BUILDING CONTROL GROUP

Address: **1105 – 1107 BARRENJOEY ROAD, PALM BEACH
NSW 2108**

Project: **PROPOSED MIXED USE BUILDING**

Report: **BCA ASSESSMENT REPORT**

Protection of openings in external walls

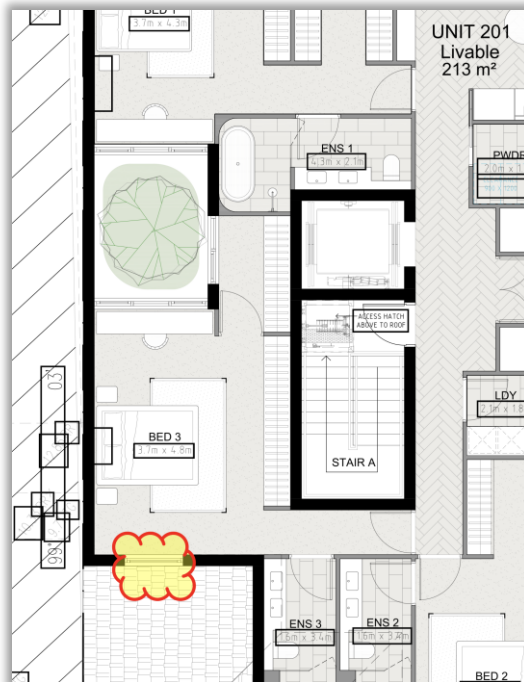
Openings in the east and west elevations of the building are located within 3m of the southern boundary from Level 1 to Level 2 and may not comply with C3.2 & C3.4 of the BCA.

A combination of deemed-to-satisfy and performance solution may be necessary to achieve compliance with the BCA.

Fire Hydrant

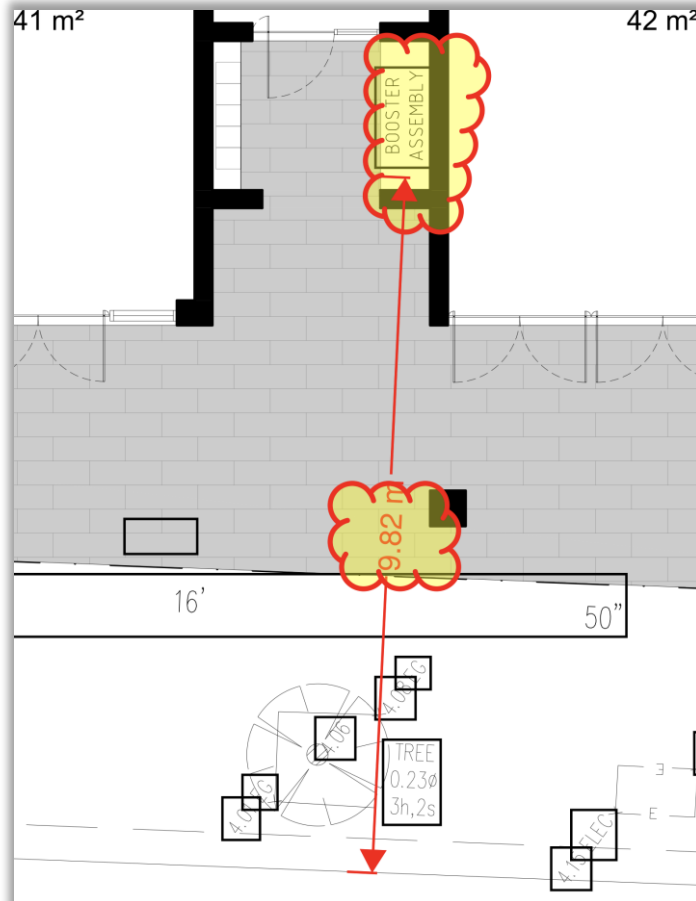
The location of the **hydrant booster assembly** is acknowledged on the plans as being provided in the vicinity below;

To this end, please find below an extract from AS2419.1-2005 regarding the criteria for locating the hydrant booster assembly depending on whether its **affixed to**, or **remote from the building**.

<p>In consideration of the above, it appears that the proposed booster assembly is affixed to the building and does not appear to comply with the following:</p> <ul style="list-style-type: none"> • Operable by fire brigade pumping appliances <u>located within 8m</u> • Separated from the building by a construction with a fire resistance rating of not less than FRL 90/90/90 <u>for a distance of not less than 2m each side of and 3m above the upper hose connections in the booster assembly.</u> <p>Where a deem-to-satisfy design is not proposed, a Fire-Engineered Performance Solution is to be prepared by a C10 Accredited Fire Engineer at the Construction Certificate stage in order to justify the non-compliance and is to address the relevant Performance Requirements of the BCA accordingly.</p>	
<p>4.</p>	<p>Bounding Construction: Class 2, Buildings</p> <p>It is acknowledged that a conflict exists between the fire-rating requirements for 'bounding construction' for sole-occupancy units, lift shaft construction and the doorways for such lift shafts. It is interpreted by <i>Building Control Group</i> that the following lift doors, illustrated below, are required to achieve an <u>FRL of '-/60/30'</u>.</p>  <p>Where a deem-to-satisfy design is not proposed, a Fire-Engineered Performance Solution is to be prepared by a C10 Accredited Fire Engineer at the Construction Certificate stage in order to justify the non-compliance and is to address the relevant Performance Requirements of the BCA accordingly.</p>	<p>C3.11</p>
